Agenda Item Details

Meeting	Aug 15, 2018 - RSD Regular Board Meeting
Category	9. Consent
Subject	9.18 Approval of Change Order with Standard Drywall
Access	Public
Type	Action (Consent)
Fiscal Impact	Yes
Dollar Amount	51,349.00
Budgeted	Yes
Budget Source	Measure G Funds
Recommended Action	It is recommended that the Change Order with Standard Drywall be approved.

Subject: Rio STEAM K-8 Campus
Rio School District
Oxnard, CA

Re: Project 0045-015 Rio STEAM K-8 Campus
BP #05 Metal Framing, Drywall and Plaster
Recommendation to Approve CO #5.8 Standard Drywall

BLK 20 D EXTERIOR WALL SECTION @ PROPOSED EXTERIOR FINISH & FINISH OF MASS REFERENCE AS APPROVED DETAIL 4WS 47

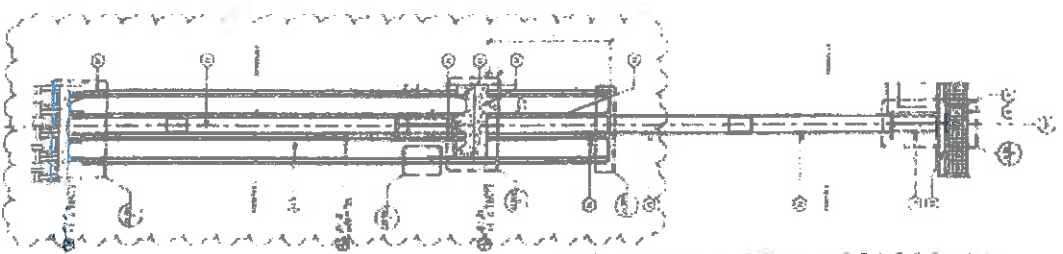
2. **Detail 4 - Modifies "As Approved" Detail 4/A6.47-See attached w/ clouds indicating change of scope.**
 - a. **Added double wall to allow panel system to wrap around structural brace framing in this area.**

A9.44

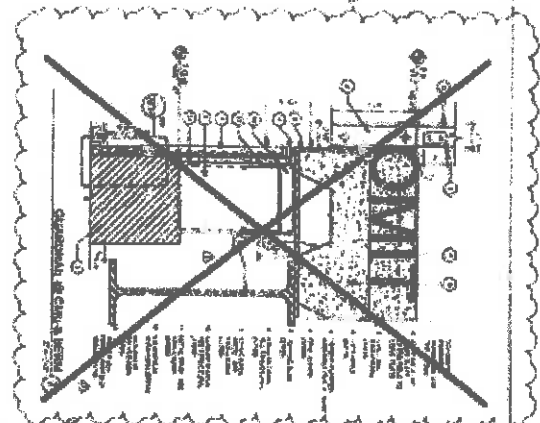
5. **Detail 7 - Modifies "As Approved" Detail 5/A9.44-See attached w/ clouds indicating change of scope.**
 - a. **Replaces metal guardrail system with Phenolic panel system parapet wall' @ 3'-6" AFF.**
